Responses to the Environmental Protection Agency Comments on the Draft Proposed Major Modification to the CAD/ROD for Operable Unit 1

Responses to the Colorado Department of Public Health and Environment Comments on the Draft
Proposed Major Modification to the CAD/ROD for Operable Unit 1

MAJOR MODIFICATION
TO THE
OPERABLE UNIT 1: 881 HILLSIDE AREA
CORRECTIVE ACTION DECISION/RECORD
OF DECISION

Rocky Flats Environmental Technology Site
Golden, Colorado

OU 1 Collection Well Trichloroethene Concentrations

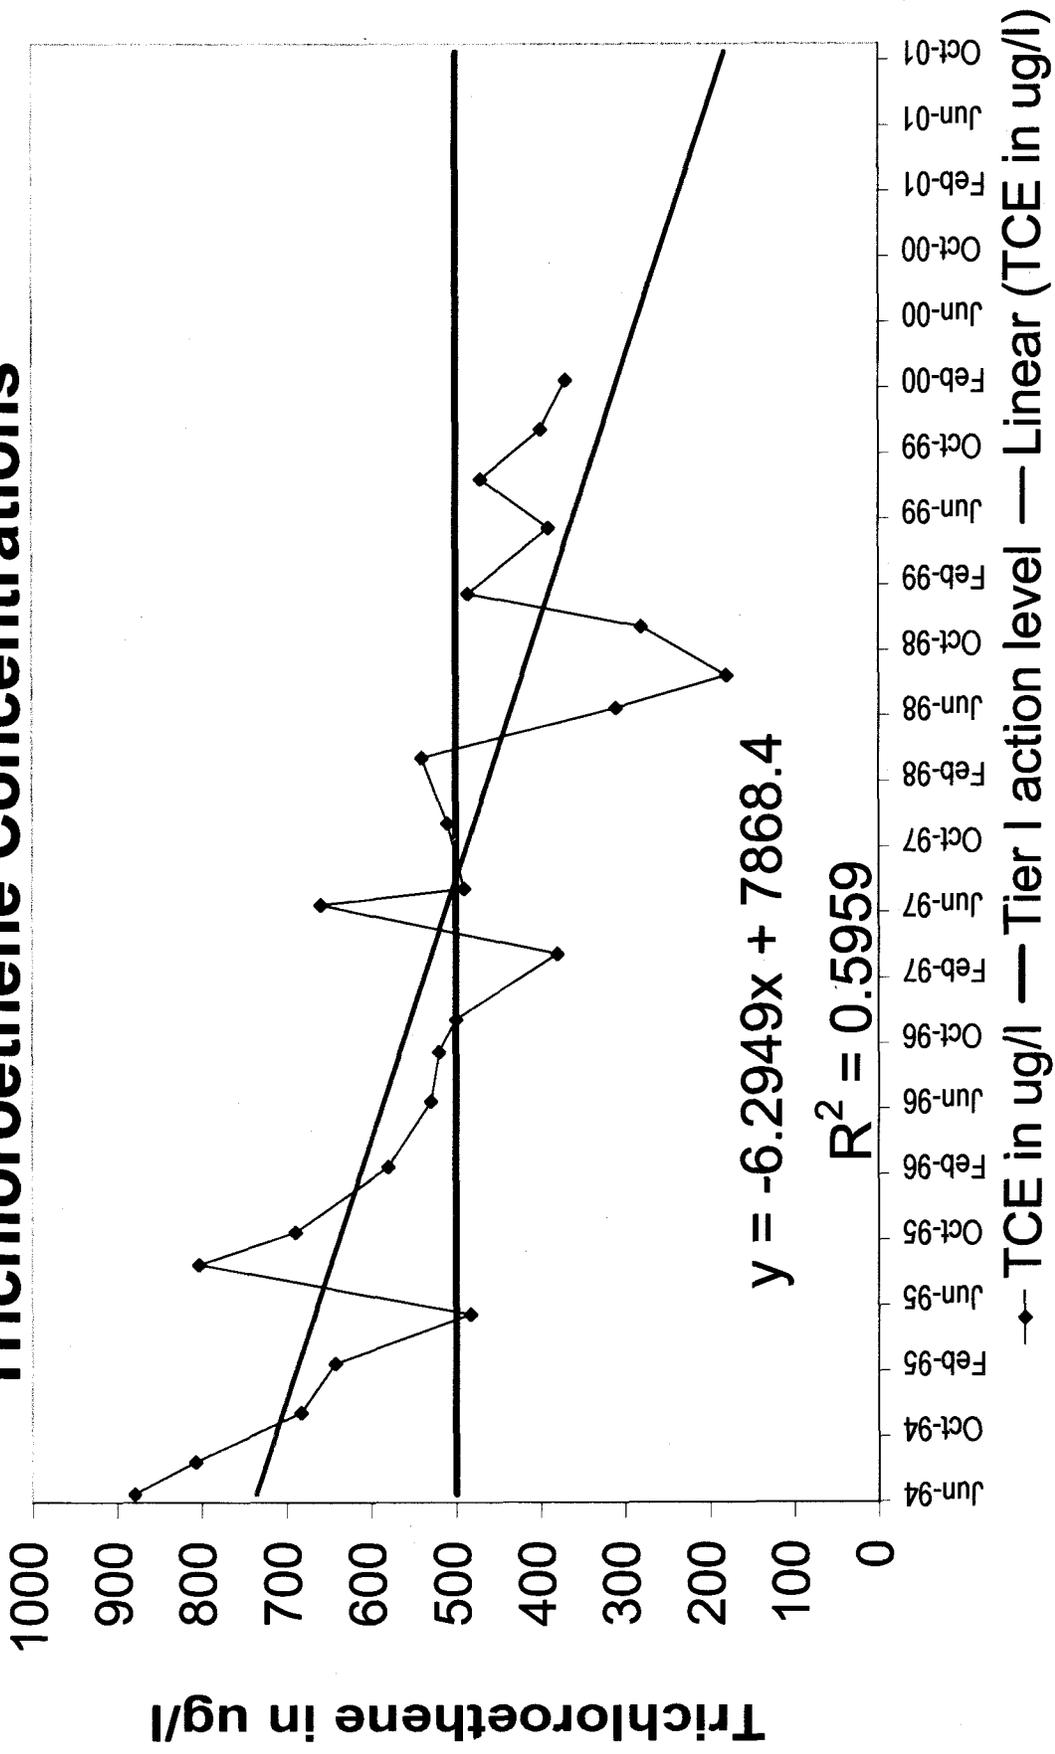
1. **Since a declining trend in concentration, as shown by a linear regression, is the justification for modifying the original remedy, the same justification should be used for discontinuing operation of the Collection Well. Cessation of pumping and treating should occur only if this linear regression of TCE concentrations continues to decline for at least one year following CAD/ROD approval.**

Concentrations of TCE in the Collection Well have remained below the Tier I action level of 500 ug/L since June 1998, and continue to show a declining trend as indicated on the attached concentration plot (also included in the CAD/ROD). Operation of the Collection Well will continue for one year after signing the Major Modification to the OUI CAD/ROD. After that time, if the declining trend for TCE concentrations in the well continue to be below the Tier I action level (500 ug/L), then pumping and treating of groundwater will be discontinued. The Collection Well will then be designated as a Plume Definition Well and monitored consistent with the RFETS Integrated Monitoring Plan.
